EGL Ref: 9702

30 January 2026

**MATAKANUI GOLD LIMITED
BENDIGO-OPHIR GOLD PROJECT - FAST TRACK APPROVALS ACT
RESPONSE TO OTAGO REGIONAL COUNCIL
GEOTECHNICAL ENGINEERING, SURFACE WATER, EROSION AND SEDIMENT
CONTROL REQUESTS FOR INFORMATION**

FIGURE 1: SC01 CATCHMENT (NORTH) AND RC03 CATCHMENT (SOUTH) EXCERPT FROM MWM REPORT²

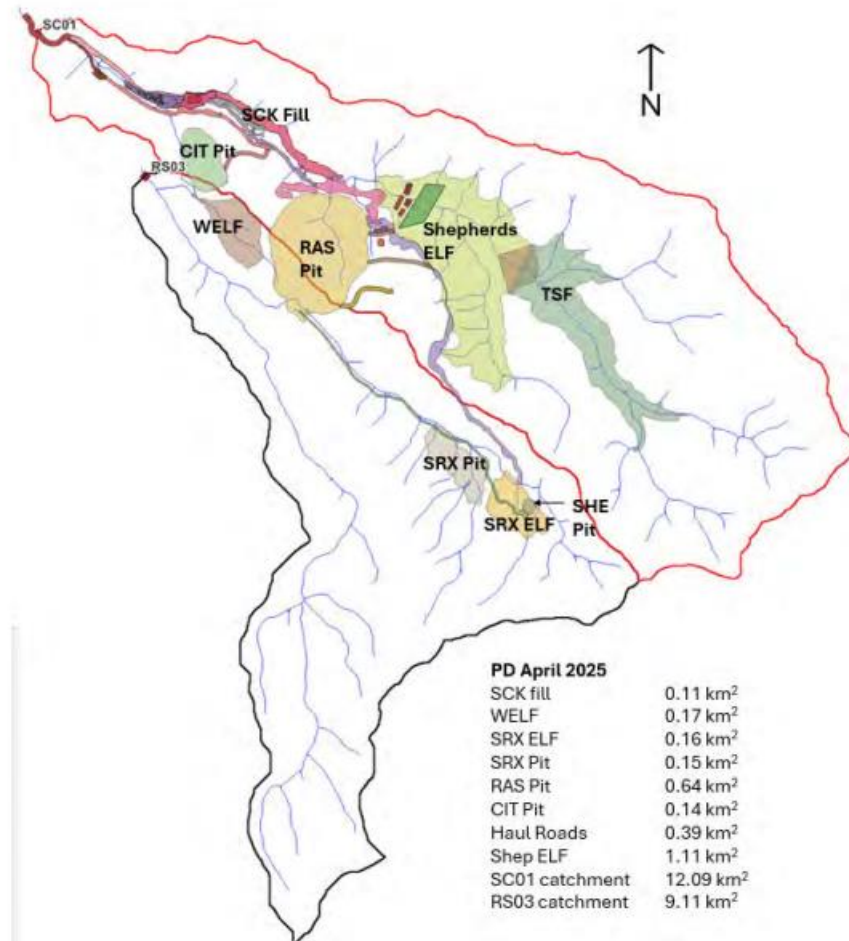
In Report B.04, Kōmanawa state that, post-closure: Overall, surface water flows in both arms of the Shepherds and Bendigo catchments would increase.

Please provide an assessment from a suitably qualified and experienced person of the predicted difference in flood magnitude between the current state and the post-closure state during an extreme event. This assessment should include an assessment of the impact of increased flows on flood hazards for receptors downstream of the development.

Kōmanawa's (B.04) statement refers to the results of the Water and Load Balance modelling by HydroGeochem presented in the MWM report, B.06, Appendix N². The HydroGeochem estimates represent average flows, not flood peak flows. The modelled post-closure increases in average flow rates for Shepherds Creek and Rise and Shine Creek are:

- Shepherds Creek (SC01), an average flow increase of 11 L/s
- Rise and Shine Creek (RS03), an average flow increase of 6 L/s

The catchment extents used for these estimates are shown in Figure 1 below.

FIGURE 4: EXCERPT FROM WETLANDS VALUES REPORT SHOWING THE EXTENT OF THE DDF AND SLSW

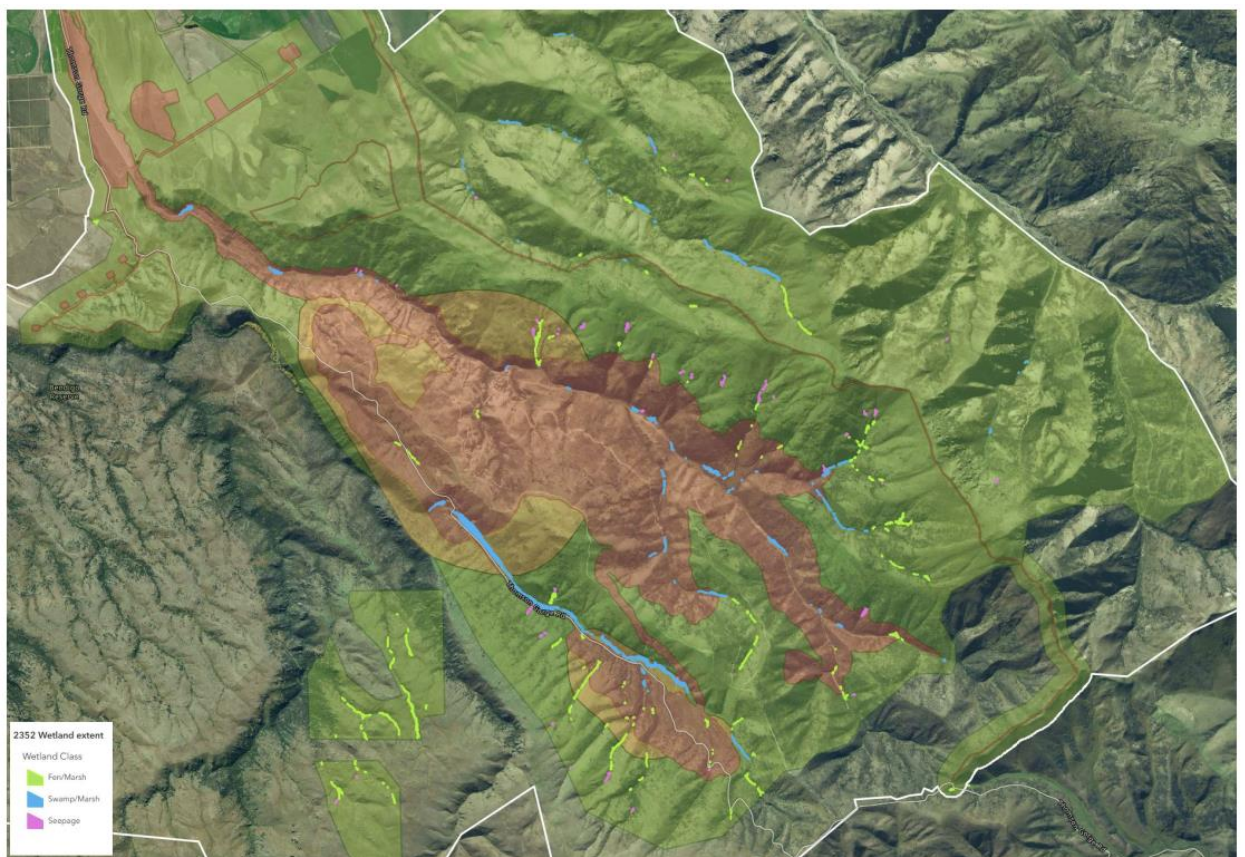
Please explain how erosion and sediment control measures will be implemented around wetlands. It appears that wetlands are not considered within the Erosion and Sediment Control Management Plan (Report G.14).

The proposed construction disturbance footprint bisects existing wetlands at several locations, and works will be undertaken in the catchment above wetlands at other locations. Figure 4 below extracted from the Wetlands Values⁶ report shows the approximate locations and extents of mapped wetlands. EGL understands wetlands within the Direct Disturbance Footprint (DDF) in red are assumed to be lost and do not require specific erosion and sediment measures. Wetlands within the Surrounding Landscape Surveyed for Wetlands (SLSW) in green require protection from sediment discharge.

Generally, it is the downstream portion of bisected wetlands that is affected by the DDF. At these locations sediment is not expected to impact upstream portions of wetlands and general erosion and sediment control measures set out in the Erosion and Sediment Control Report⁷ and the Erosion and Sediment Control Management Plan⁸ apply.

Wetlands located outside and downstream of the DDF require specific erosion and sediment measures such that there is no material discharge of sediment to the wetland as the primary objective. This may require higher standards of erosion and sediment controls, and monitoring; however, will be specific to each location.

We propose the Site-Specific Erosion and Sediment Control Plans consider whether wetlands are present and require additional management measures, and that this requirement is added to the Erosion and Sediment Control Management Plan⁸.
